LONDON BOROUGH OF ENFIELD

PLANNING COMMITTEE

14/02806/OUT Stonehill Estate, Silvermere Drive, London, N18 3QH

RECOMMENDATION:

DATE DECEMBER 2013	SCALE 1:1250@A1	DRAWN IN
		CHECKED AW
DRAWING NUMBER 30371-PL-104D

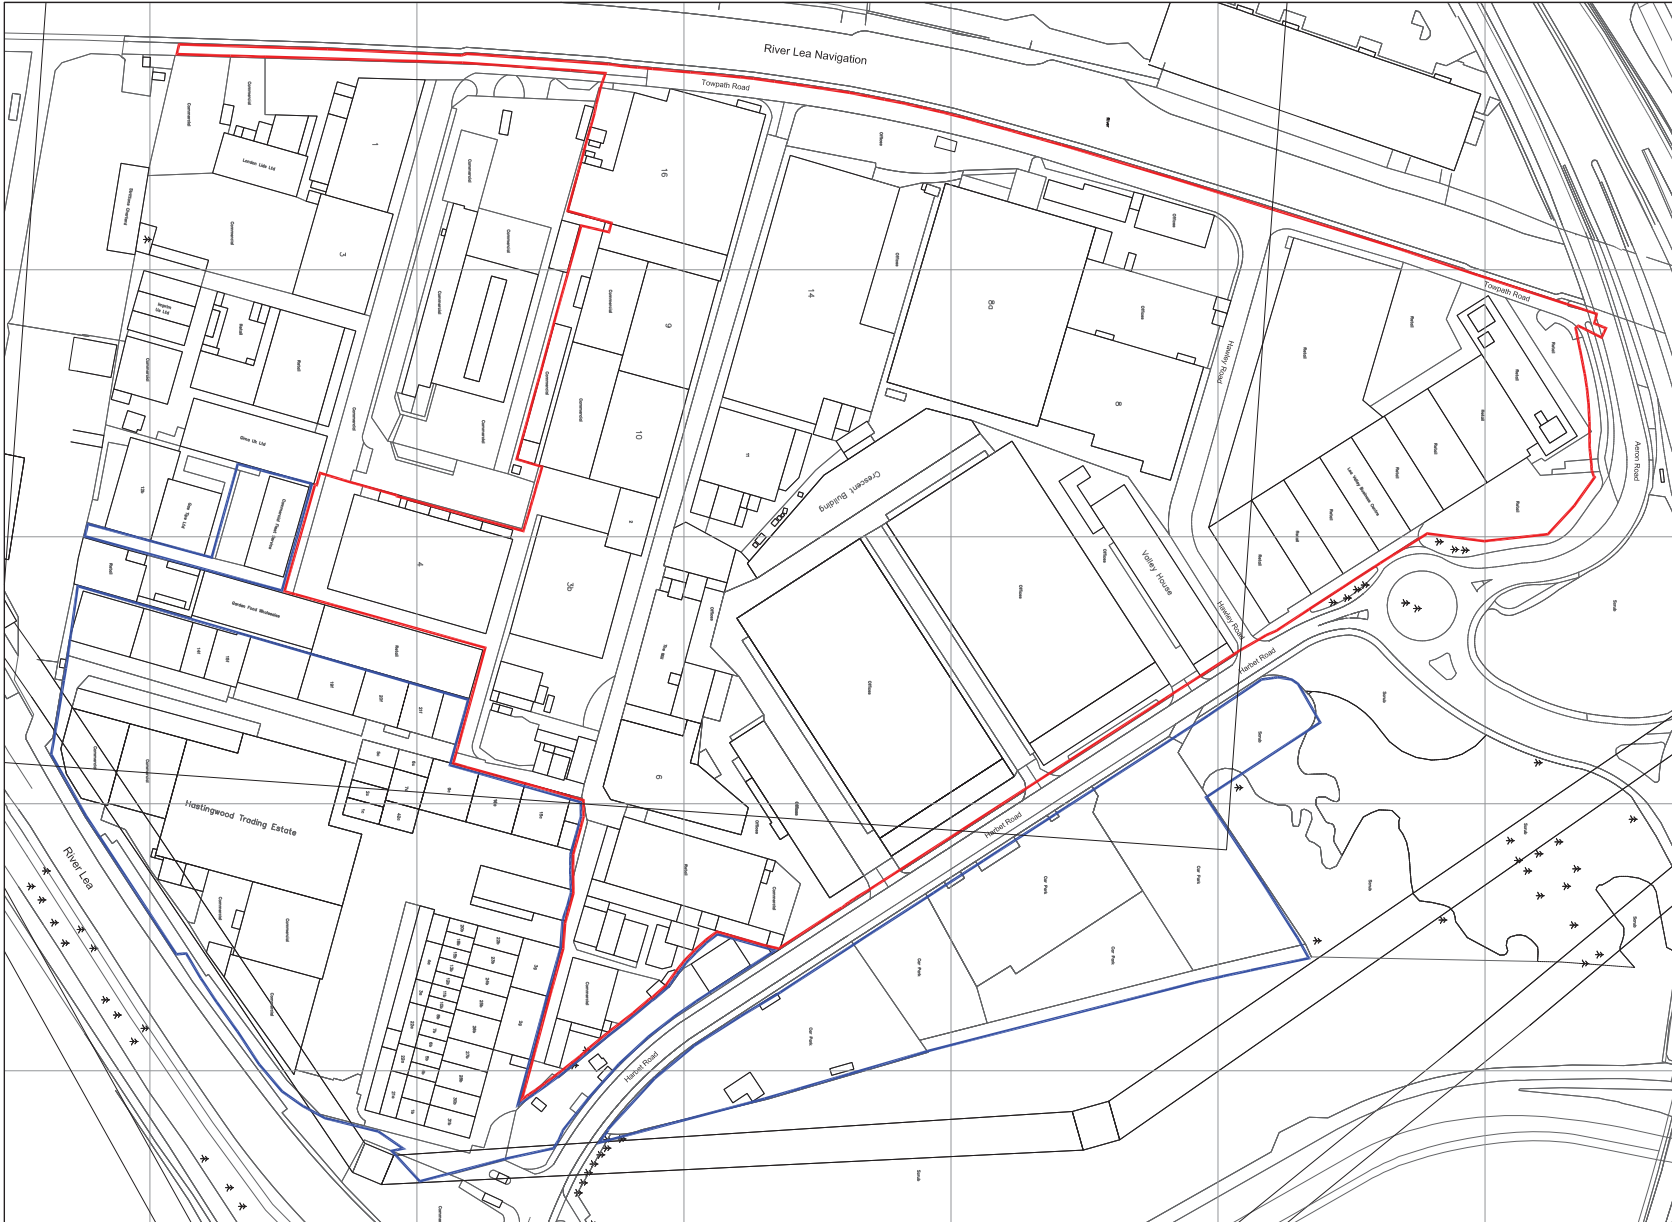
- 6.4.11 Instead, the key plan in the proposal is the Development Parameters Plan (drawing number 30371-PL-104D) shows a road running along the waterside made available for heavy goods vehicle (HGV) parking/turning and car-parking which leaves no specific improvement for landscaping or provision for cyclists and pedestrians. Whilst the map shows indicative arrows for cyclists and pedestrians, these users have no priority areas or segregated road space. Furthermore, this approach to the design of this important canal side frontage would not provide the quality of environment which will be necessary to support active frontage or mixed use development as set out in the Masterplan.

TITLE
STONEHILL ESTATE, ENFIELD
 DRAWING
**ILLUSTRATIVE MASTERPLAN
 OPTION 1**
 CLIENT
**FAIRACRE &
 LASALLE INVESTMENT MANAGEMENT**

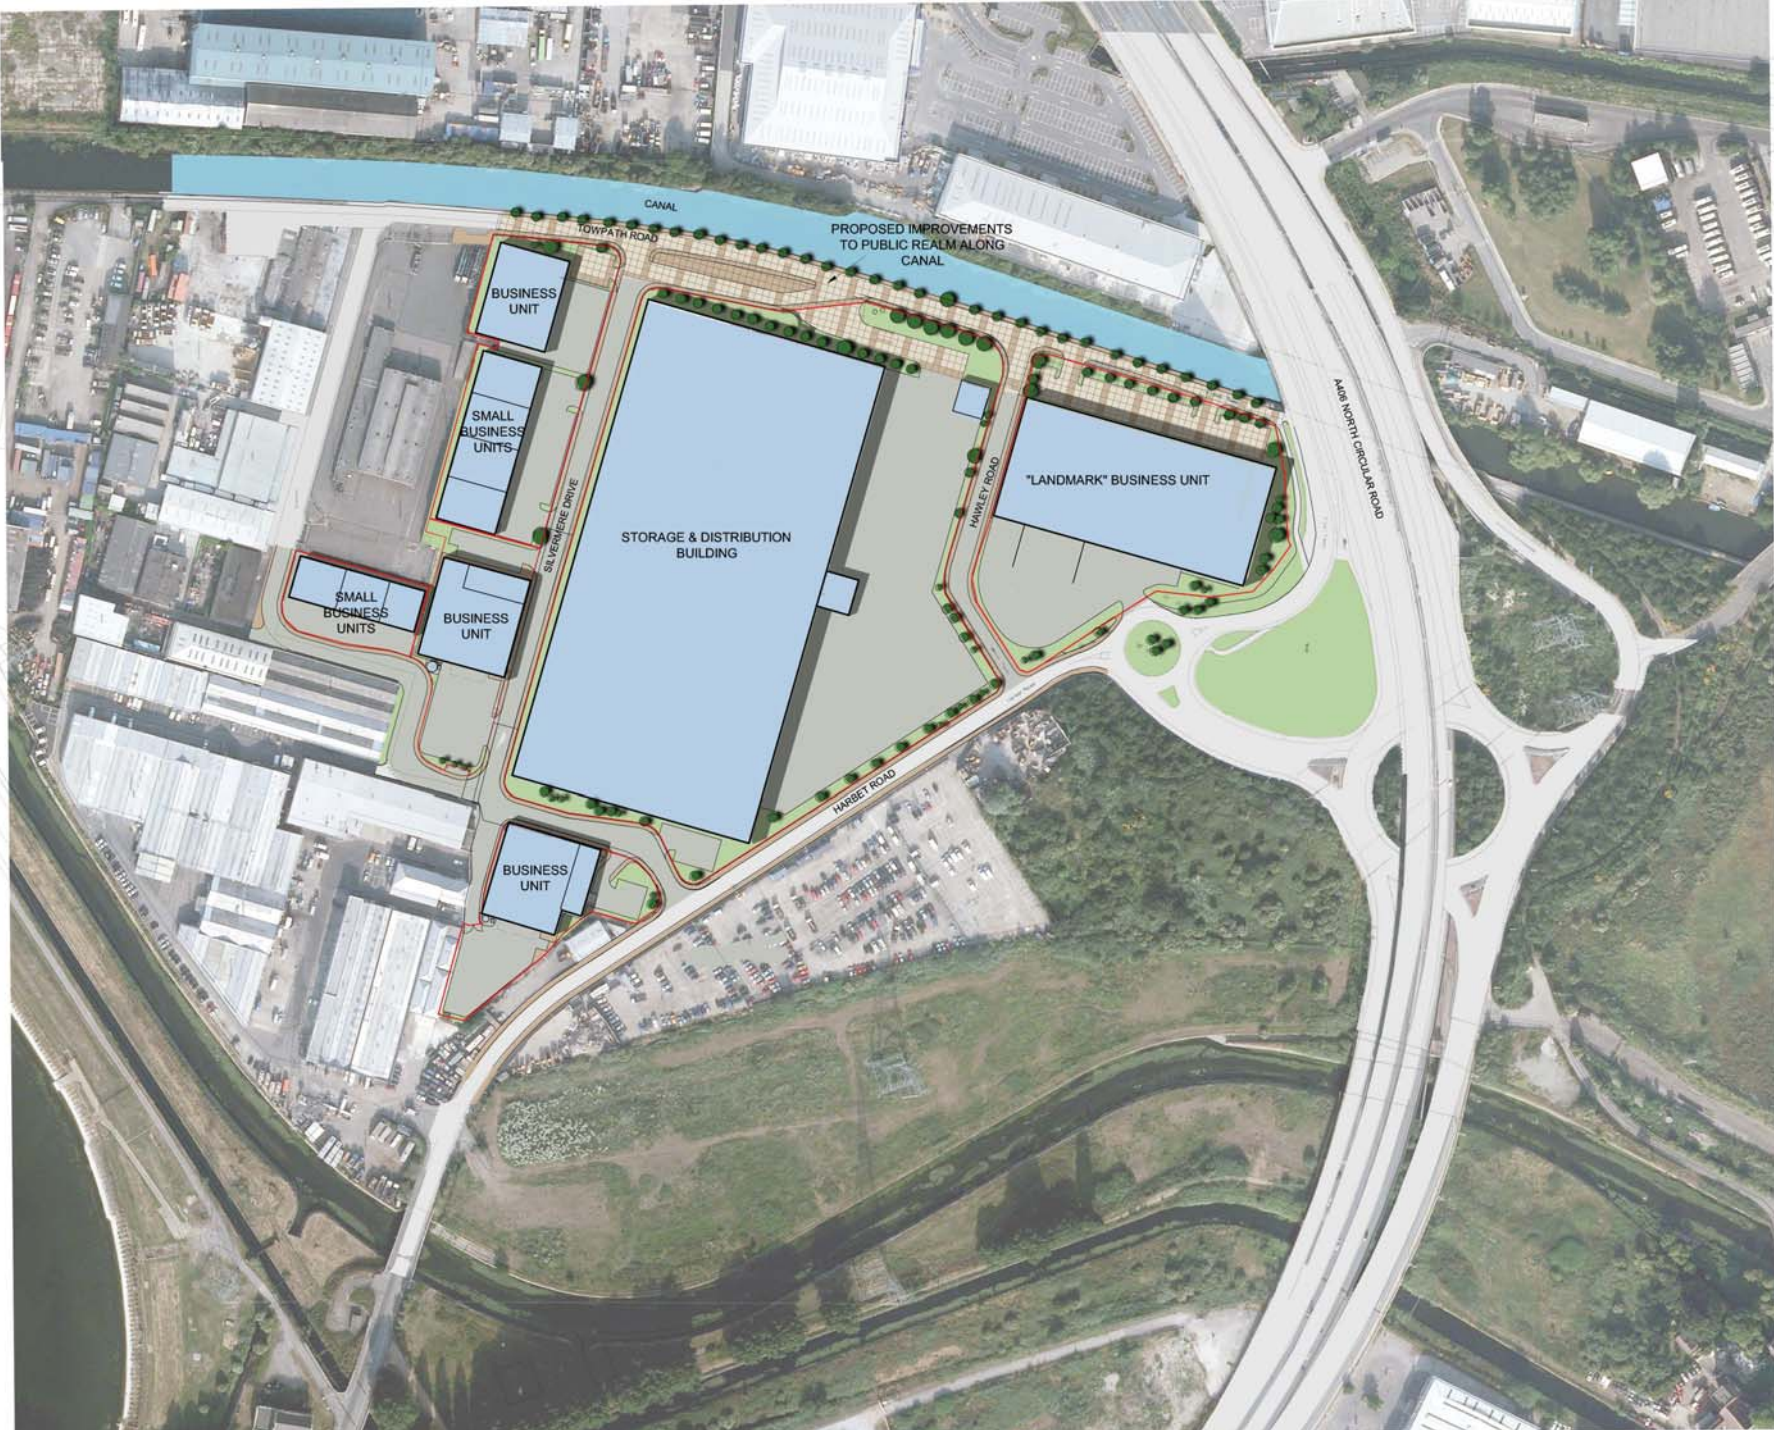
- 6.4.10 It should be noted that the outline proposal includes plans showing improvements to the towpath area which are illustrative only (Drawing no.s 30371-PL-120B and 30371-PL-121B), and therefore cannot be relied upon to understand the final layout of the site.
